4. **CASE 22. 073, 120 MOORE STREET, John William Moore Two-family House, c1896 (NORTH ELMWOOD)**
2½ stories, clapboarded hip-roofed structure, virtually the reverse image of 118. Moore, one of the original occupants, was a roofer.
CONTRIBUTING

Applicant/Contractor: Bright Planet Solar, 103A Millbury Street, Auburn, MA 01501

Owner: Eduardo Tavaréz, 120 Moore Street, Providence, RI 02907

Proposal: The scope of work proposed consists of Minor Alterations and includes:

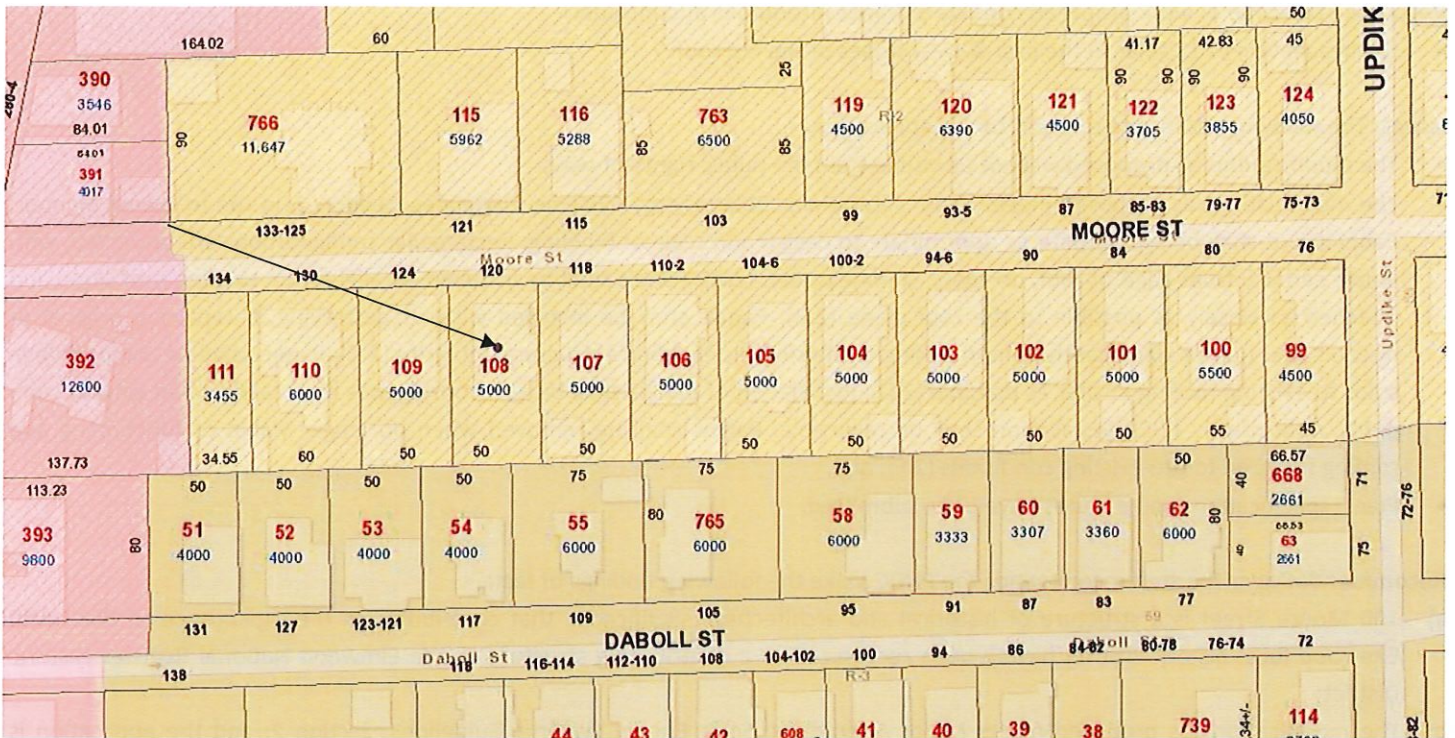
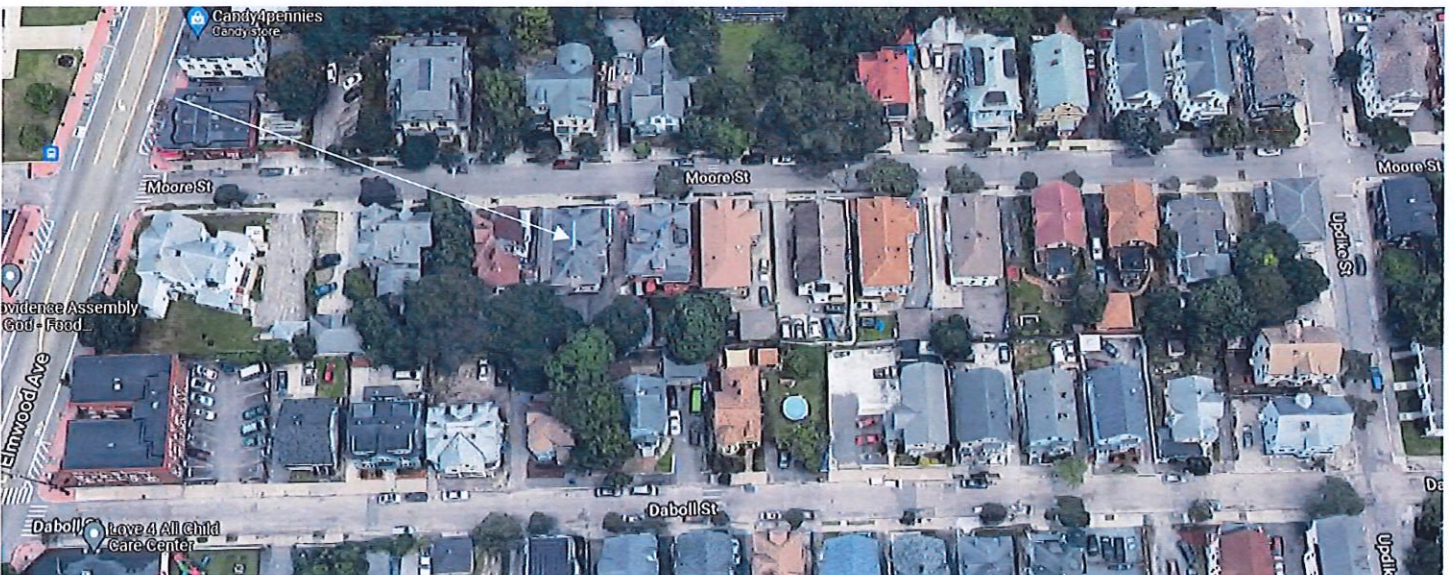
- The modifications as proposed will not be visible from the public rights-of-way;
- The modifications as proposed meets Minor Alterations: Solar Energy Systems Guidelines, Section 2, in the following manner: Panel layout shall be sympathetic or appropriate to design and scale of building. Rectangular configurations are preferred, with ample setback from edge of roof, dormers, chimneys, etc. (2.A); Panels shall be installed parallel to the existing roof slope and matched as closely as possible to the roof plane (2.B); Panels shall be installed without destroying or replacing original or historic materials or significantly compromising or altering the building's structural integrity (2.C); Panels shall be compatible in color to existing roofing insofar as possible (2.D); Installation of panels shall be as inconspicuous as possible when viewed from public right-of-way (2.E); Installation shall be reversible. Panels shall be removed when no longer viable or functioning and roofing restored to pre-existing conditions (2.F); and,

- c) The work as proposed is in accord with PHDC Standards 8 & 9 as follows: 8) the work will be done so that it does not destroy the historic character of the property or the district as they are not on the primary elevation and will be minimally-to-not visible from the public rights-of-way; and, 9) Whenever possible... alterations to structures shall be done in such a manner that if removed in the future, the essential form and integrity of the structure and the site will be unimpaired.

Staff recommends a motion be made stating that: The application is considered complete. 120 Moore Street is a structure of historical and architectural significance that contributes to the significance of the North Elmwood local historic district having been recognized as a contributing structure to the Elmwood National Register Historic District. The Commission grants Final Approval of the proposal as submitted as the proposed alteration is appropriate having determined that the proposed alteration does not destroy the historic character of the property or the district and are historically and architecturally compatible with the property and district as the proposed alteration meets Minor Alterations: Solar Energy Systems Guidelines, Section 2, is reversible and will not have an adverse effect on the property or district as they are not on the primary elevation and will be minimally-to-not visible from the public rights-of-way (Standards 8 & 9), and the recommendations in the staff report, with staff to review any additional required details.
